737

Service Bulletin

Number: 737-28A1206
Original Issue: January 11, 2006
Revision 2: May 21, 2009
ATA System: 2822 3152

SUBJECT: FUEL - Distribution - Center Fuel Tank Boost Pump Auto Shutoff and Master Caution Logic Change

FIGURE 58: P61-8 FUEL TEST PANEL INSTALLATION

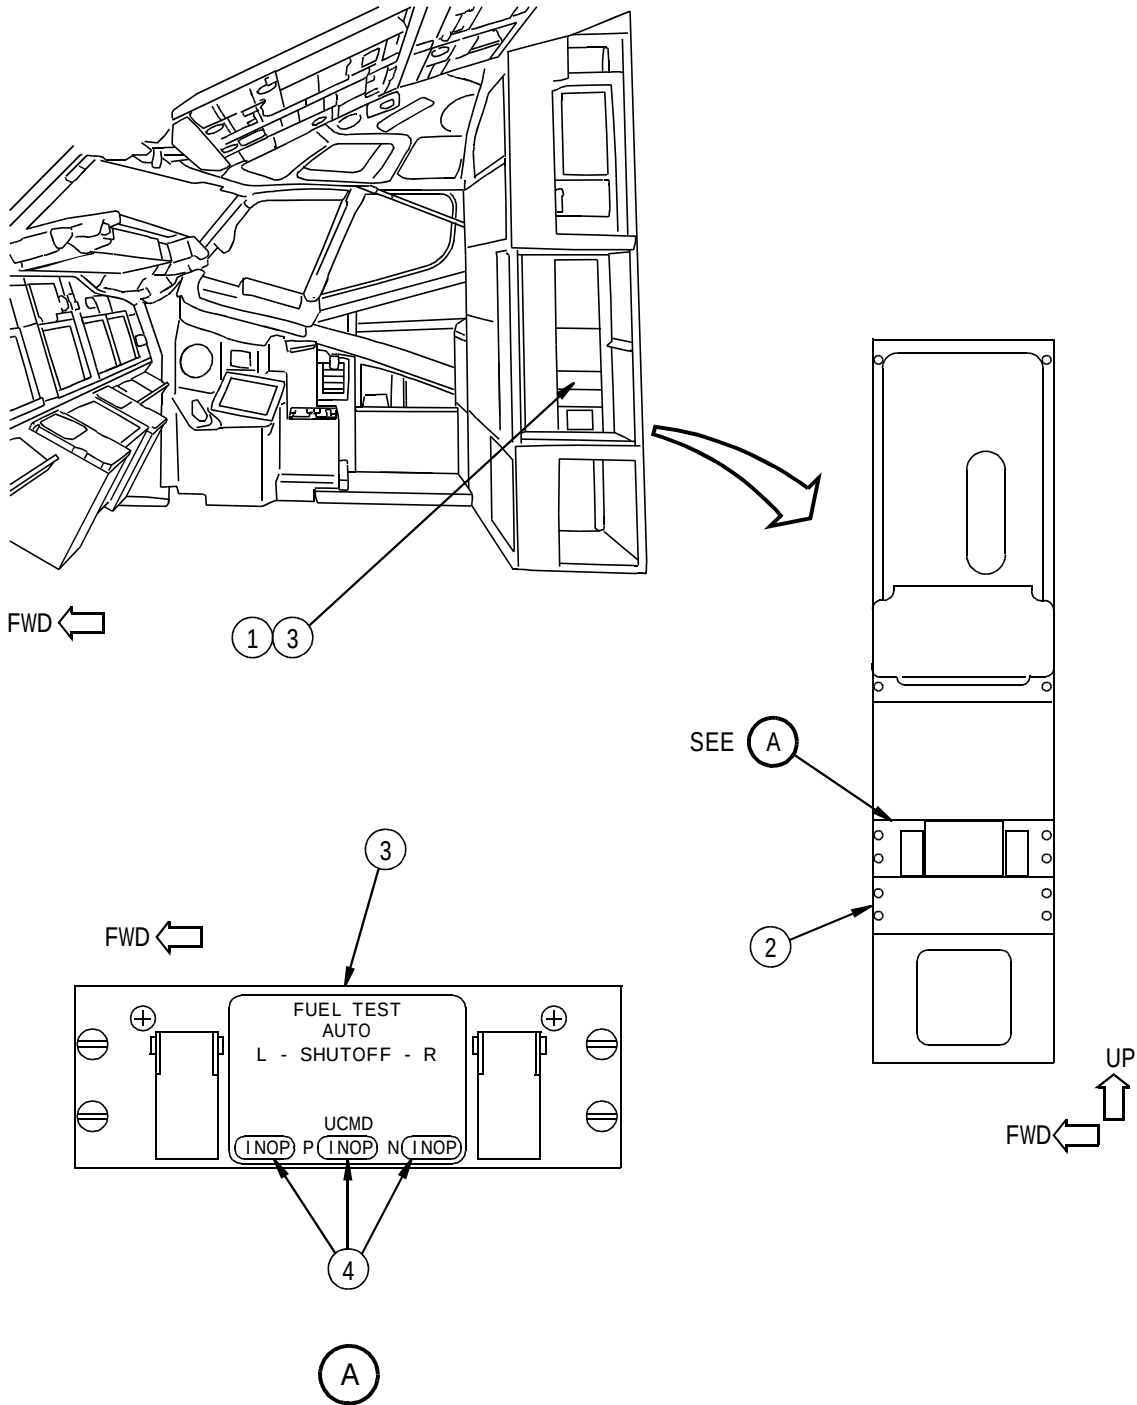
Figure 58 - Added an optional part number panel to P61-8 Fuel Test Panel Installation.

FIGURE 59: P61-8 FUEL TEST PANEL INSTALLATION

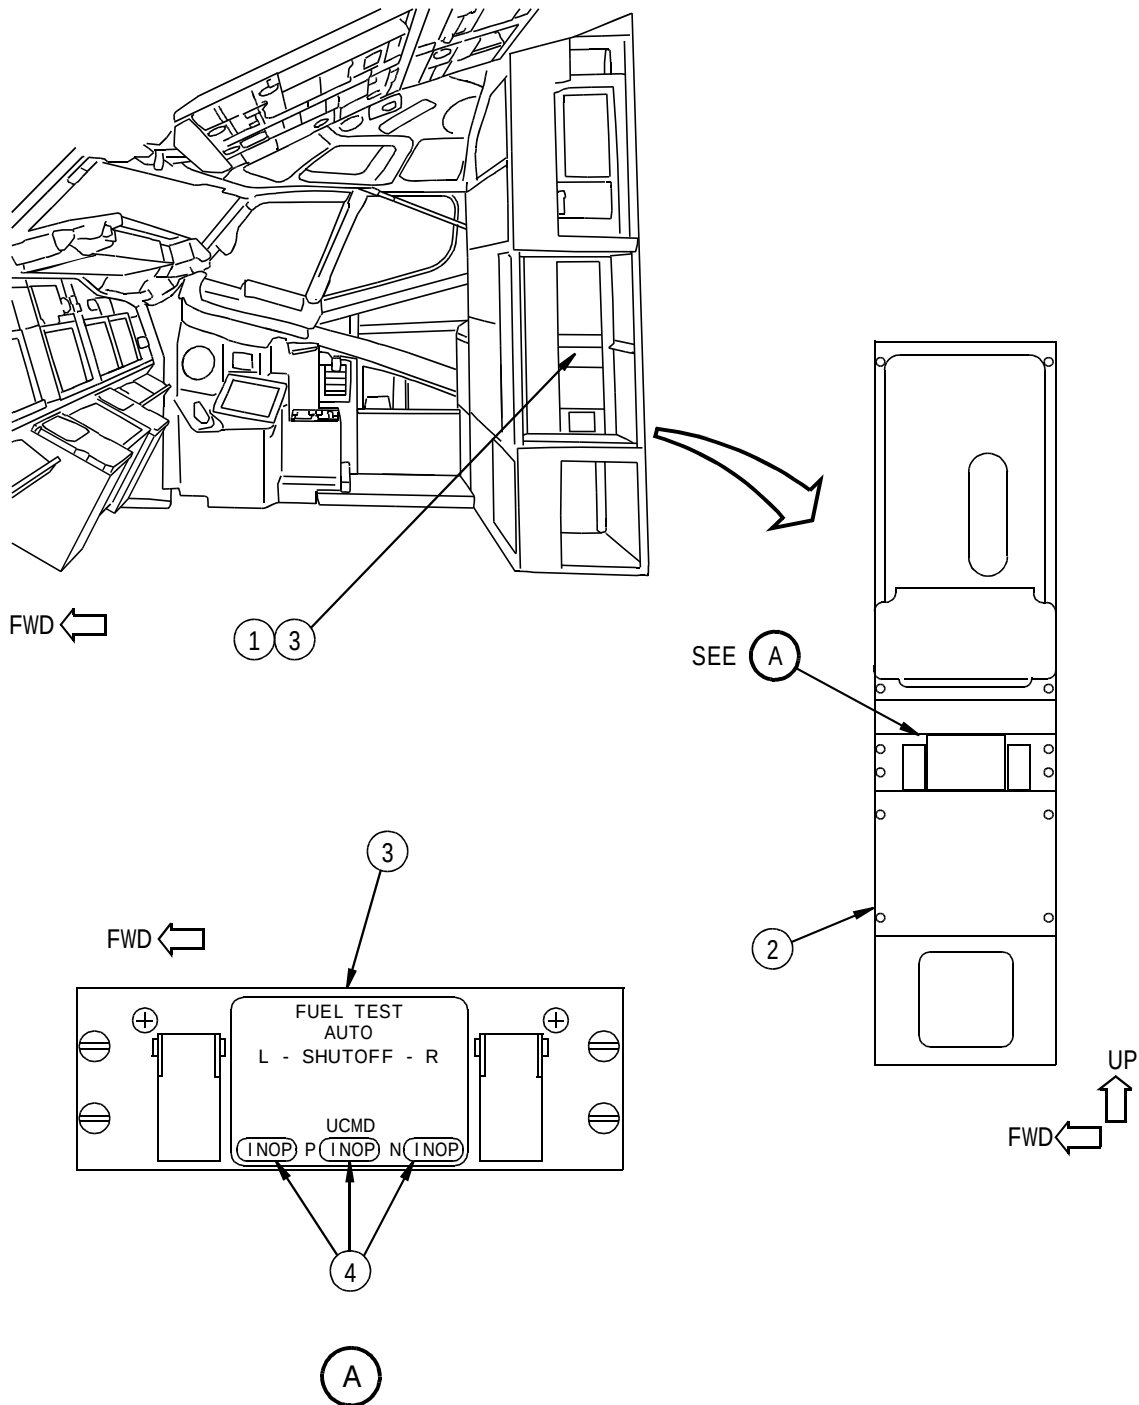
Figure 59 - Added an optional part number panel to P61-8 Fuel Test Panel Installation.

FIGURE 60: P61-8 FUEL TEST PANEL INSTALLATION

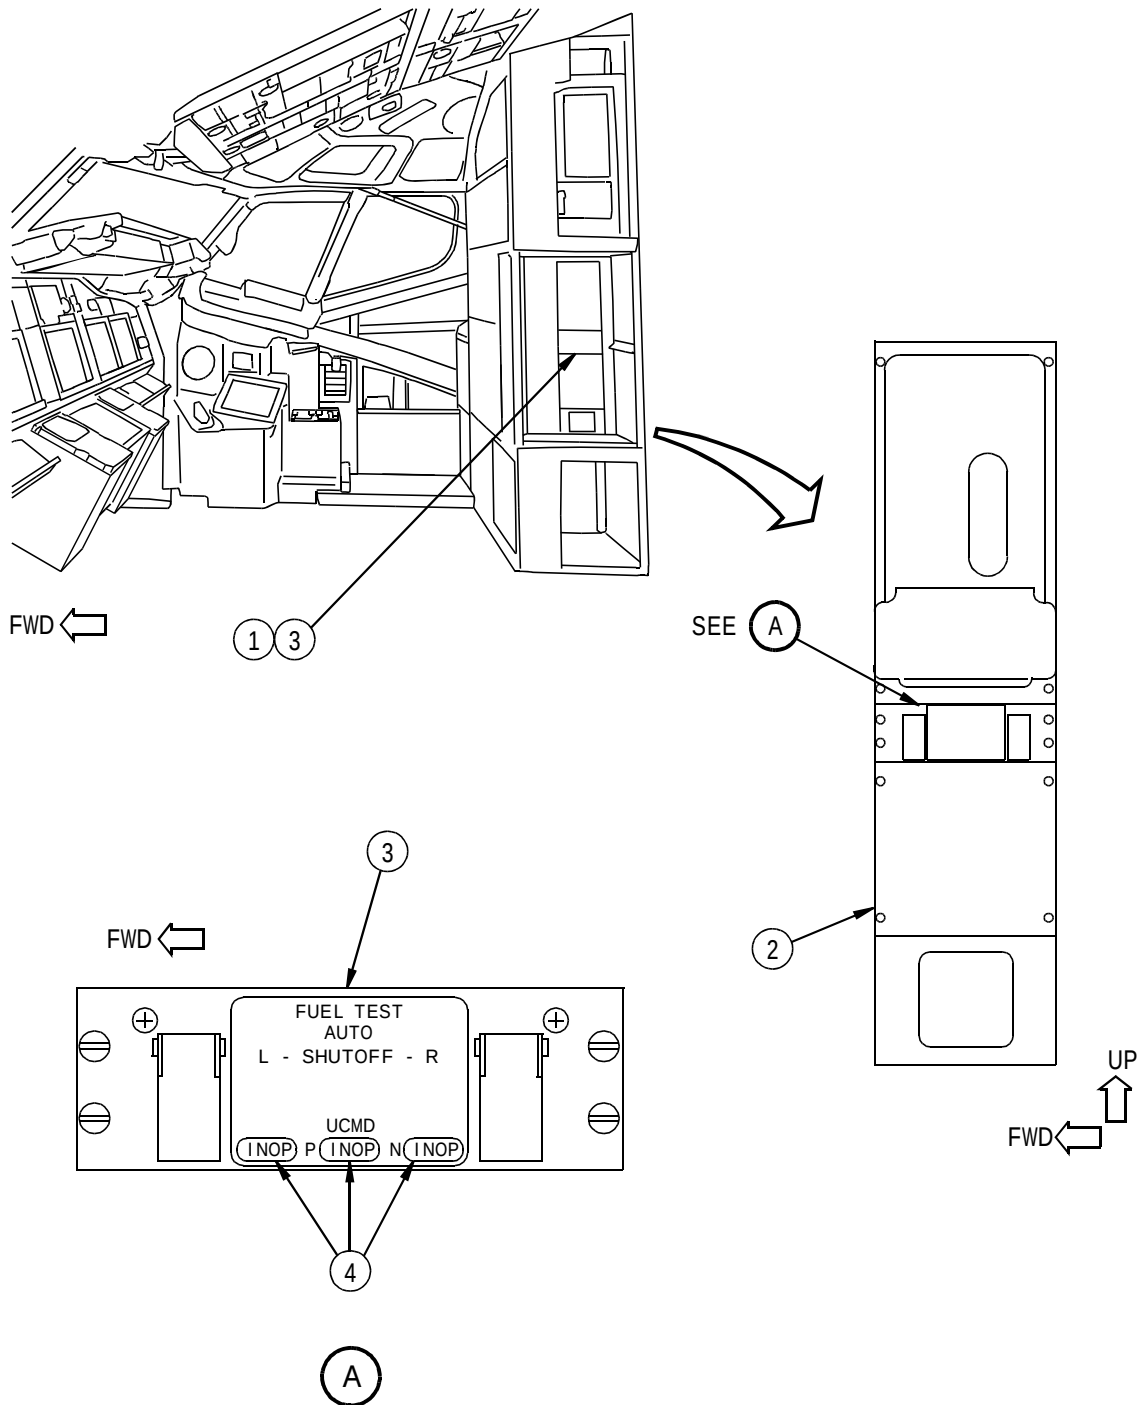
Figure 60 - Added an optional part number panel to P61-8 Fuel Test Panel Installation.
